RS-02-028

Braidwood Station, Units 1 and 2  
Facility Operating License Nos. NPF-72 and NPF-77  
NRC Docket Nos. STN 50-456 and STN 50-457

Byron Station, Units 1 and 2  
Facility Operating License Nos. NPF-37 and NPF-66  
NRC Docket Nos. STN 50-454 and STN 50-455

Subject: Request for License Amendment for Technical Specifications - DC Electrical Power Systems

SURVEILLANCE REQUIREMENTS (continued)

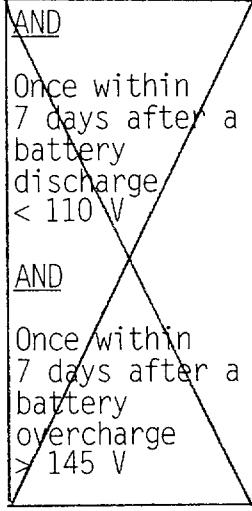
SURVEILLANCE	FREQUENCY
SR 3.8.6.2	<p>each battery pilot cell float voltage is <math>\geq 2.07\text{V}</math></p> <p>Verify battery cell parameters meet Table 3.8.6-1 Category B limits.</p>	<p>31 92 days</p> 
SR 3.8.6.3	<p>each battery cell electrolyte level is greater than or equal to minimum established design limits</p> <p>Verify average electrolyte temperature of representative cells is <math>\geq 60^\circ\text{F}</math>.</p>	<p>31 92 days</p>
SR 3.8.6.4	Verify each battery pilot cell electrolyte temperature is greater than or equal to minimum established design limits	31 day 2
SR 3.8.6.5	Verify each battery cell float voltage is $\geq 2.07\text{V}$ .	92 days
SR 3.8.6.6	(see SR 3.8.4.8 markup)
